## EXHIBIT C ARRL PETITION FOR RECONSIDERATION

#### Analysis of Distance Extrapolation of Field Strength Calculated from the Antenna Models Provided to the FCC in the BPL Notice of Rulemaking Comments and Reply Comments

Figure 13 -- These data are from testing performed in Briarcliff Manor, NY. The emissions were not strongest at the devices marked with vertical dashed lines on this graph, but peaked approximately 150 meters away.

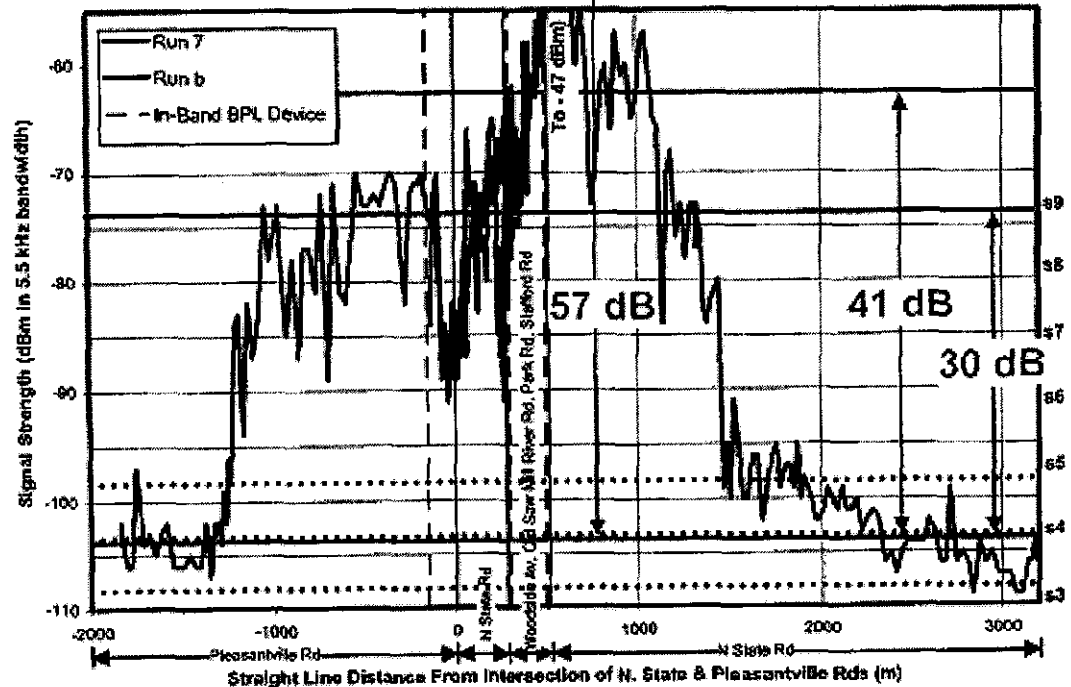
Test results like those shown above demonstrate that the original NTIA recommendation to search 1200 meters of power line for the point of maximum emissions has considerable merit. Finding the point of maximum emissions is done easily with a receiver and antenna installed on a motor vehicle. The point of maximum RSL can be noted, and more detailed calibrated field-strength measurements can be performed at that location. The Commission used a similar method to generate some of these graphs and ARRL assembled a mobile test fixture that can make such RSL measurements at normal driving speeds. This is not an expensive technique, and based on the experience of the ARRL staff, finding these peak signal-strength areas would not be a burden on companies making field-strength measurements for compliance purposes.

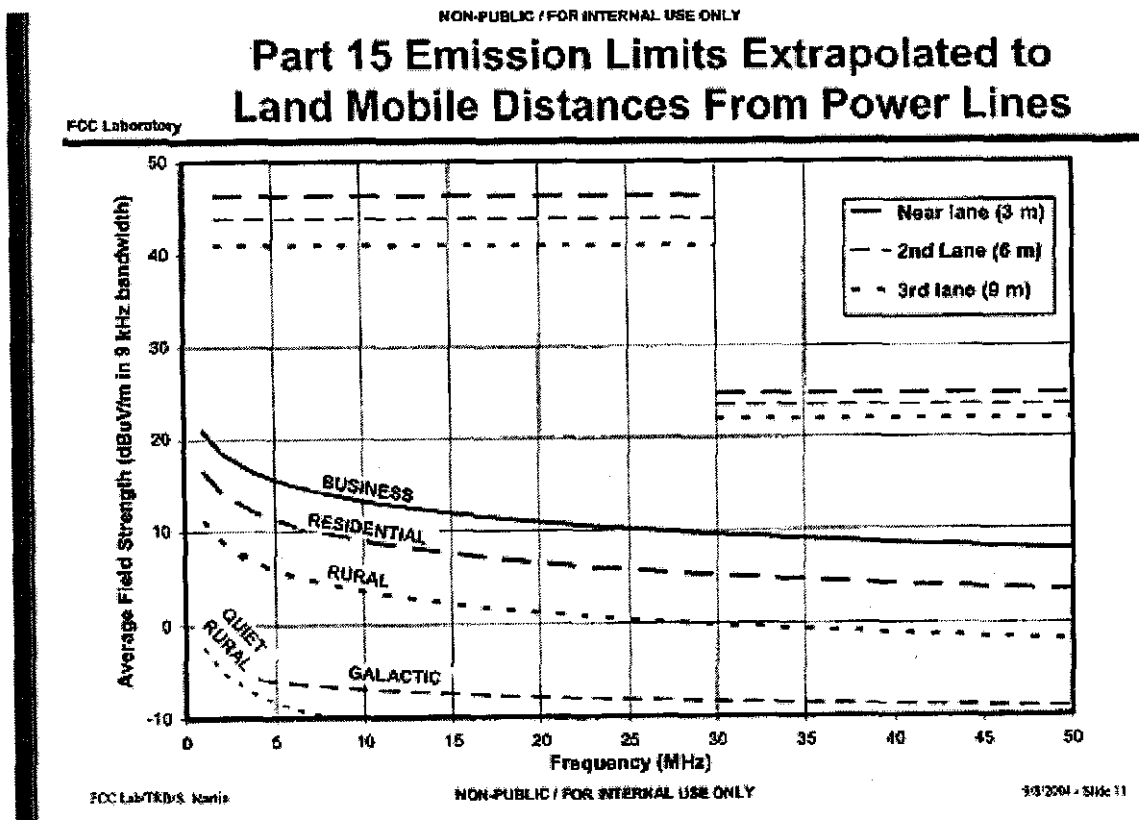
Figure 14 -- In the R&O, the Commission had concluded that the levels ARRL had requested -- notching of 40 dB to protect Amateur mobile operation -- had not been justified by the record. The FCC's own test data contradicts this, as the levels shown in this graph support ARRL's position. In fact, based on this graph, ARRL's position was conservative. This graph

shows as much as 46 dB of degradation from the median values of man-made noise<sup>4</sup>.

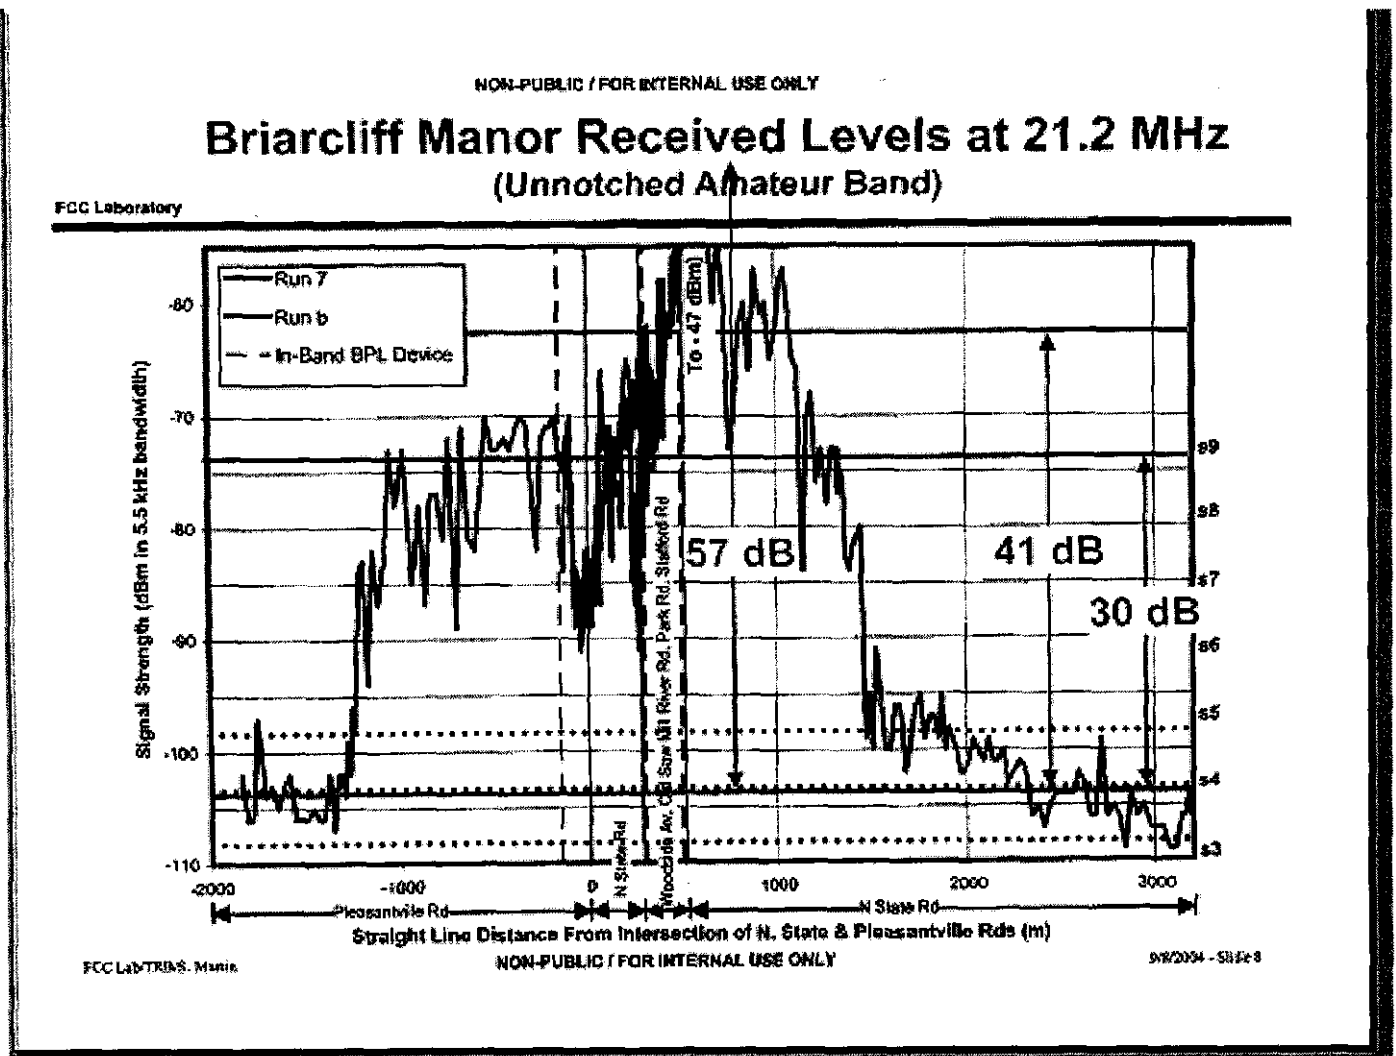
Figure 15 -- This graph shows an extremely strong BPL system causing a minimum of 57 dB of degradation to the communications capability of the Amateur Radio Service. The degradation is still at least 30 dB 1000 meters from the BPL device. These data were taken along Pleasantville and North State Road in Briarcliff Manor, NY. The maximum signal level of -47 dBm is a receiver signal-strength level of approximately S9+26 dB. These data were collected in Briarcliff Manor, NY in un-notched spectrum on 21.2 MHz. The minimum ambient levels recorded were approximately -108 dBm. The average of the ambient levels recorded was -104 dBm.

These data show that the BPL signal was at least 57 dB above the average value of the ambient noise present in the area and approximately 62 dB higher than the

minimum value of ambient levels. BPL equipment operating at this level would require 60 or more dB of notching to avoid causing harmful interference to weaker signals received by a mobile amateur station configured in a similar manner to the FCC mobile receiver.

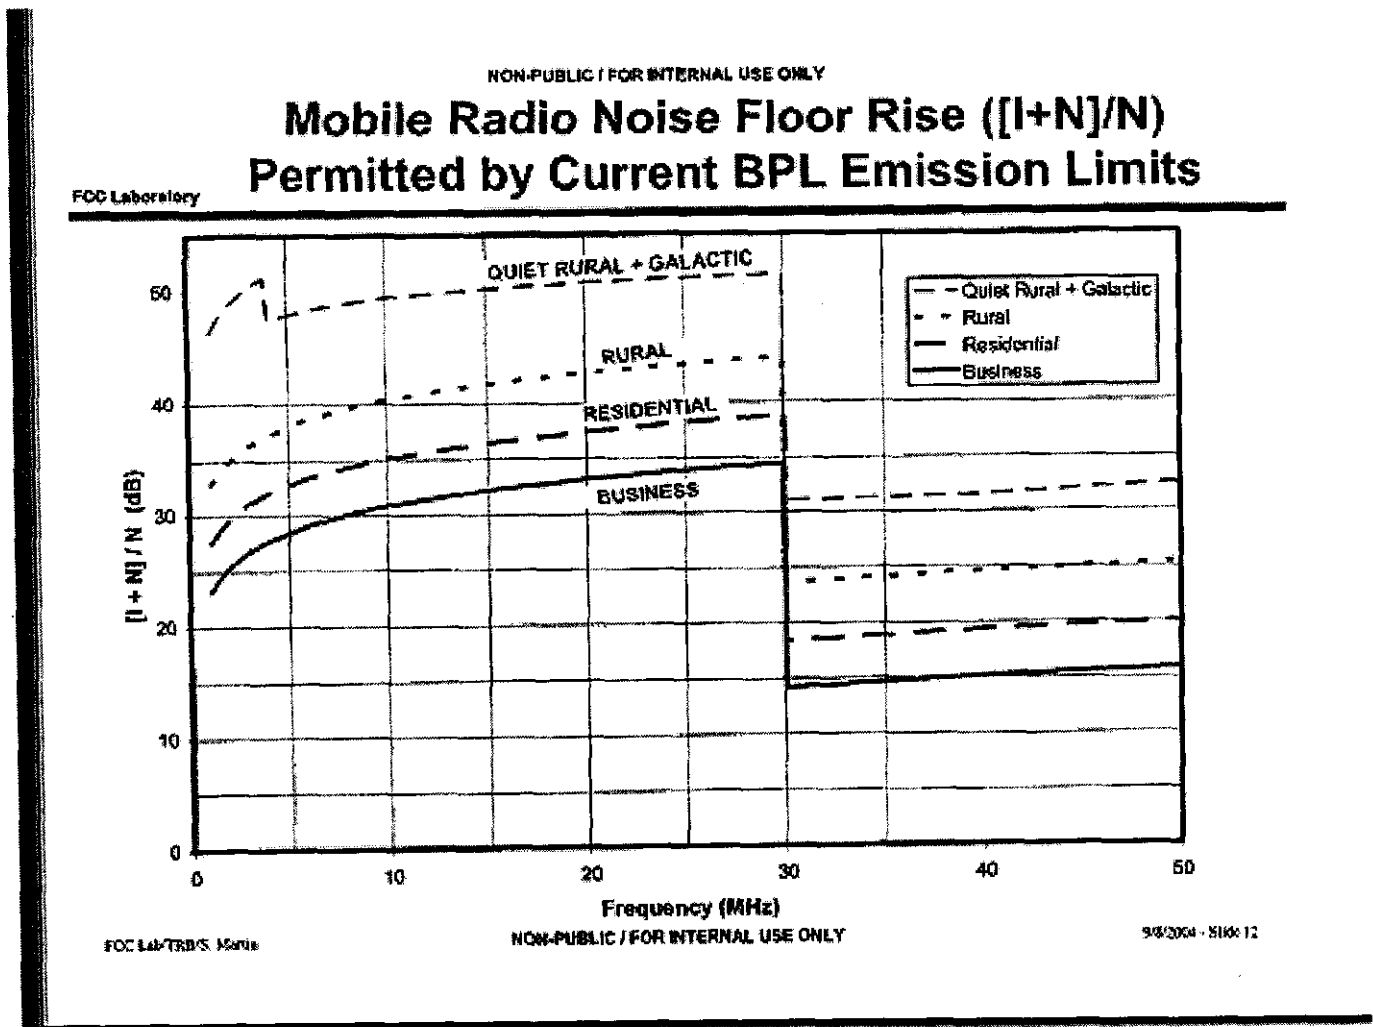
Figure 16 -- This graph shows the probable amount of degradation that is predicted to occur locally from BPL systems operating at the present FCC limits. These calculations are based on the median values of man-made noise and the field strength at a distance of 30 meters. Most antennas that will be affected by BPL will be located at or less than 30 meters distance from the source. Antennas located closer, such as mobile antennas located approximately 10 meters from the radiating power lines, will be degraded by an additional amount based on the specific distance extrapolation factors are used to make compliance measurements at that location<sup>5</sup>.

<sup>5</sup> For example, if a 40-dB/distance decade factor is used as described in the present FCC Part-15 rules, approximately 20 dB more degradation than this will occur to mobile stations operating near BPL.

Figure 18 -- This graph shows that the FCC typically measured notch depth of only 24 dB. Note that the notches are not deep and their skirts are not sharp.

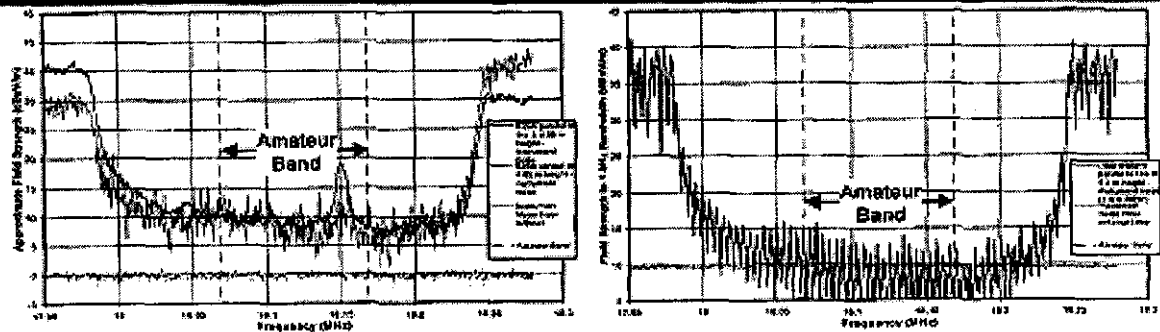
The Commission found that the notch depth that was achieved in practice was about 24 dB. In graphs shown earlier in this analysis, Commission staff had calculated that BPL operating at the present limits would degrade spectrum by 40 dB or more. In measurements made by operators in the Amateur Radio Service, degradation of approximately 15 dB was seen in “notched” spectrum. The Commission data is in excellent agreement with those measurements. Signals in the Amateur Radio Service are often weak, operating at or just a few dB above the ambient noise level. Degradation of 15 dB will obstruct many of the signals routinely used by operators in the Amateur Radio Service.

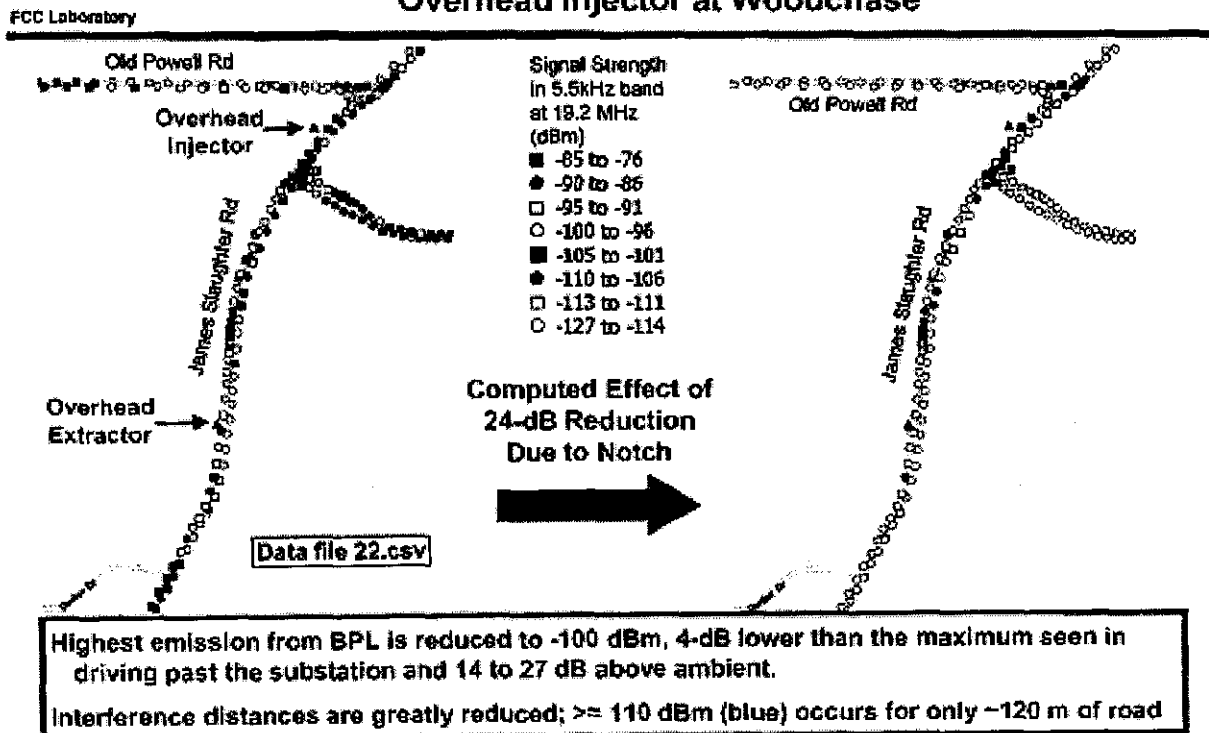
Figure 19 -- It is not possible to tell from the black and white rendition of this slide just what RSLs were present at each location shown. It is apparent, however, that the FCC testing shows that the notching allegedly used to mitigate BPL interference leaves BPL signals from 14 to 27 dB above ambient noise levels, again in good agreement with ARRL measurements. Even a few dB of degradation will obstruct some signals that could otherwise be used for communications. This graph shows that although the interference potential is reduced by notching, inadequate notching will significantly reduce the geographical area in which interference-free reception can be expected to occur.

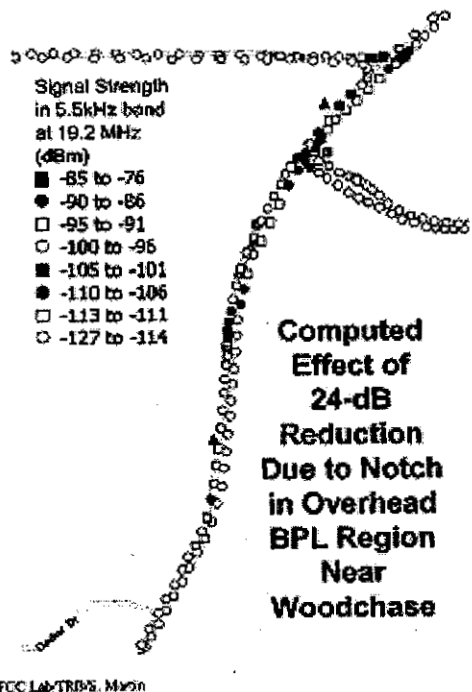
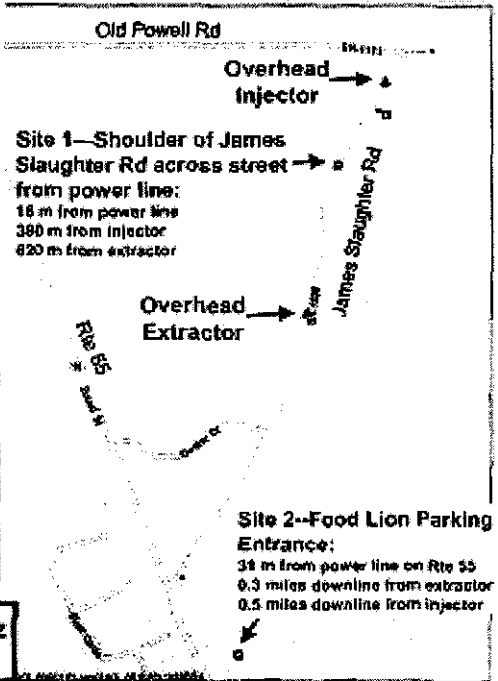
Figure 21 – This slide characterizes BPL signal encroachment on amateur bands as “weak, moderate or strong,” depending on frequency and location. ARRL presumes that the “moderate” levels are representative of the 14 to 27 dB described in other slides. Site 1 is 16 meters from the power line, 390 meters from the BPL injector. At site 2, located 31 meters from the power line, 0.5 miles from the injector, interference was still characterized as “moderate.” In this case, the mitigation techniques used were insufficient to protect an amateur station that would be located 0.5 miles away from the BPL source.

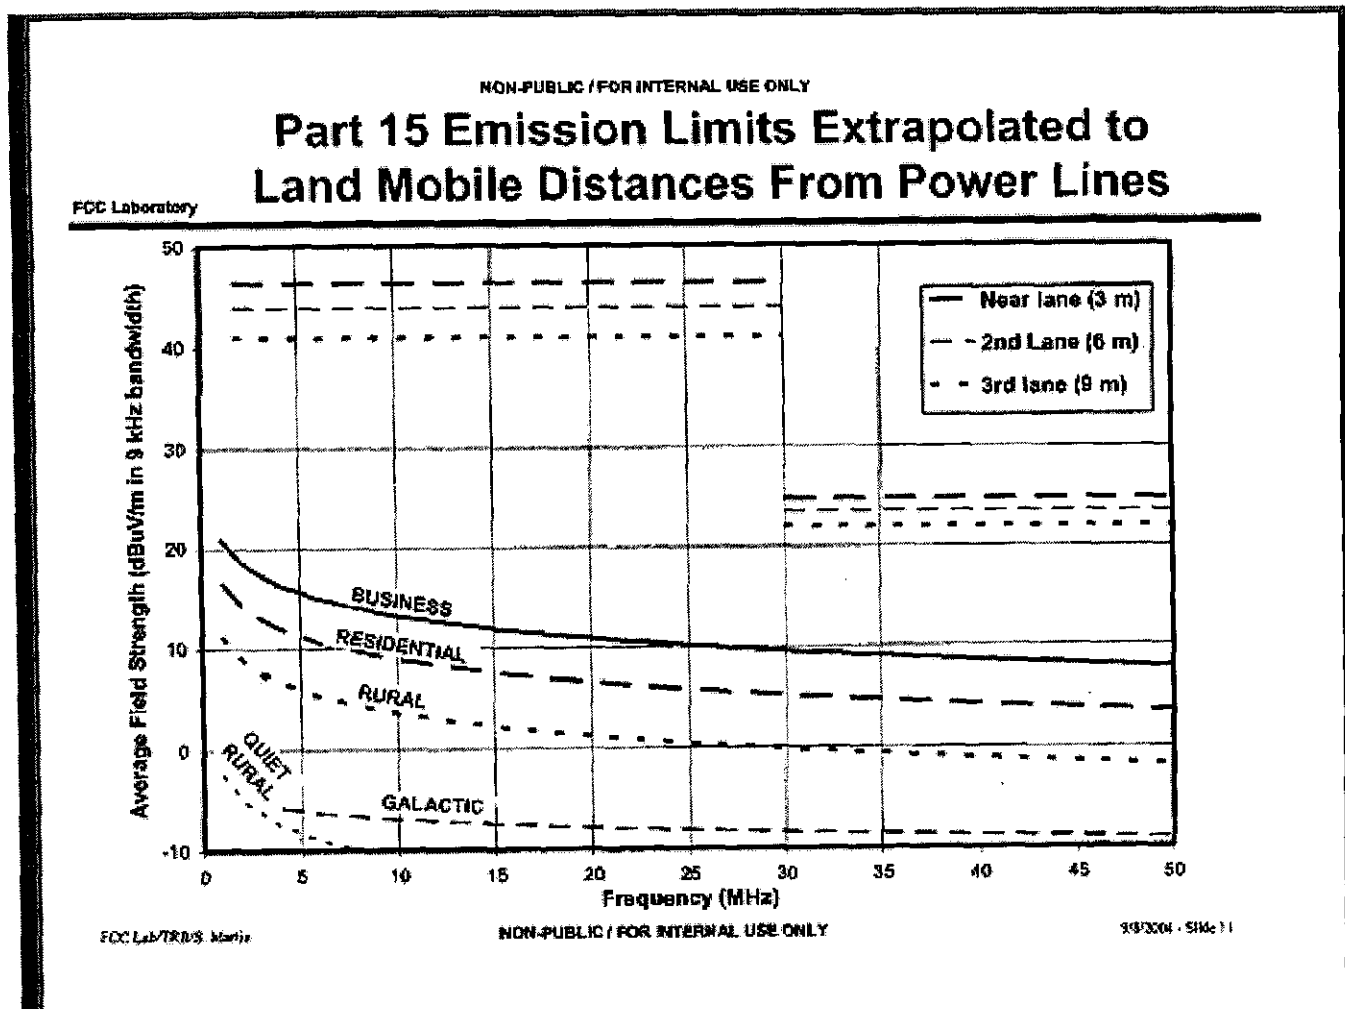
Figure 22 -- Among other things, this slide shows the typically referenced levels of man-made noise outlined in Recommendation ITU-R P.372-8, adjusted to show the levels expected in a 9 kHz bandwidth. For a number of reasons explained herein, these levels are reasonably consistent with the level of 0 dBuV/m that ARRL had recommended as a minimum protection for mobile Amateur Radio operation.

The noise levels shown in Figure 22 above are derived from Recommendation ITU-R P.372-8. These levels were determined in the 1970s to provide information about man-made noise levels in various environments. The term "residential" would include a wide range of human habitats, from apartment buildings in close proximity to electrical wiring to single-family homes located in suburban neighborhoods. The values

shown are the median levels measured. Half of the values measured were below the levels shown. Man-made noise can range from broadband noise that is present in some areas but not in others to discrete signal sources from computers and switch-mode power supplies that are present on some frequencies but not on others. Most man-made noise is also sporadic in time duration, so most of the time, in most locations a communications channel could be found that is at a much lower level than the median values shown above.

In its submissions in response to the NPRM and the NOI, ARRL described measured levels along the street in residential environments with single-family homes ranging from  $-10$  dBuV/m to  $0$  dBuV/m. It had recommended that a minimum protection level of  $0$  dBuV/m at a mobile antenna should be required to prevent most mobile stations from experiencing harmful interference. The R&O claimed that the Commission did not find  $0$  dBuV/m to be a credible representation of the man-made noise that would be typically found in the quiet portions of the  $28$  MHz Amateur allocation, even though that number is consistent with the noise levels found in the ITU-R Recommendation and the FCC report, as shown above.

Figure 23 -- This graph shows data from the BPL system at Briarcliff Manor, NY. It was taken using a receiver and a mobile whip antenna along 5000

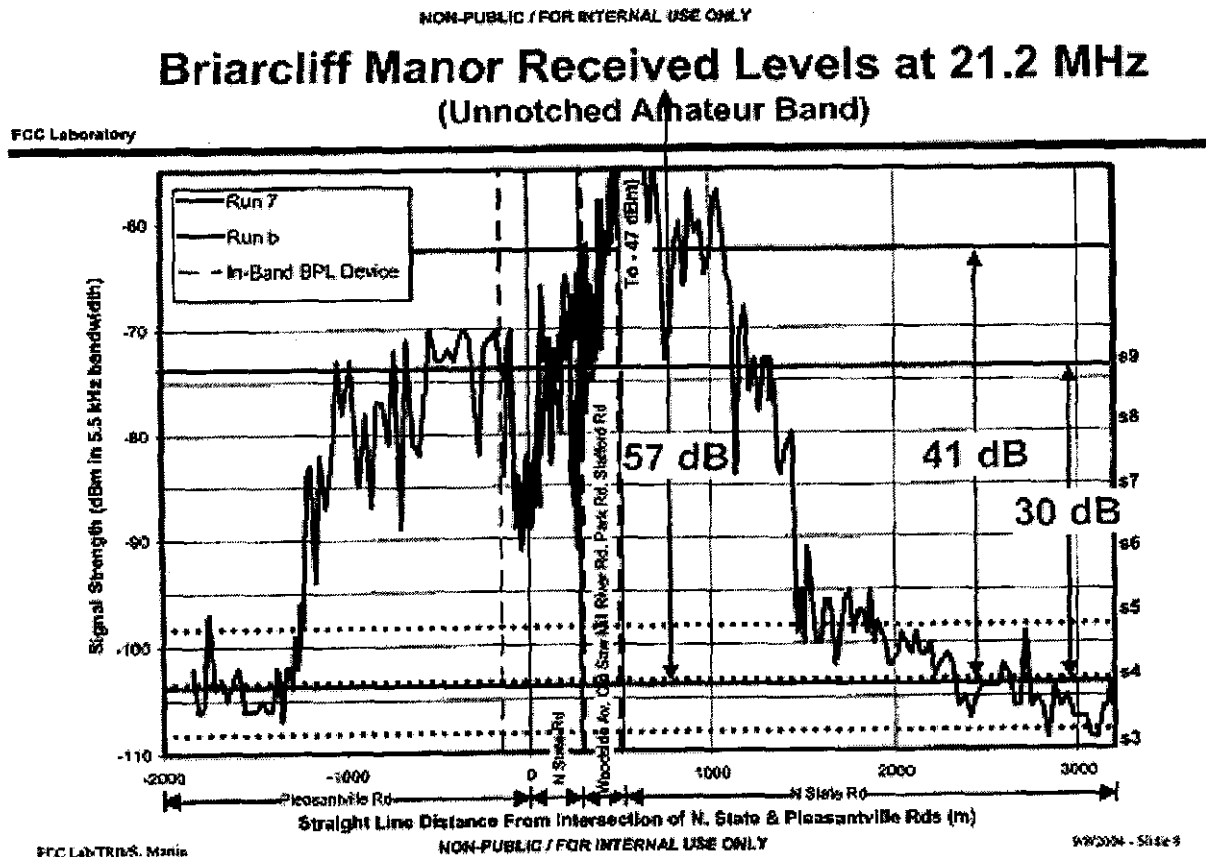
meters of overhead power line on 21 MHz. The ambient noise level is expressed as a received signal level (RSL) at the receiver, but with the antenna factor of a typical mobile whip on 21 MHz (-0.8 dB/m), the level of ambient noise indicated on this graph of -105 dBm represents a field strength of 3.3 dBuV/m. A receiver's signal strength meter typically responds to peak signals, so this ambient noise level correlates well with the level of 0 dBuV/m that ARRL told the FCC was necessary to protect mobile stations from harmful interference from BPL systems. The minimum RSL shown on this graph is below -110 dBm, representing field strength less than 0 dBuV/m. This, too, is consistent with ARRL's measurements.
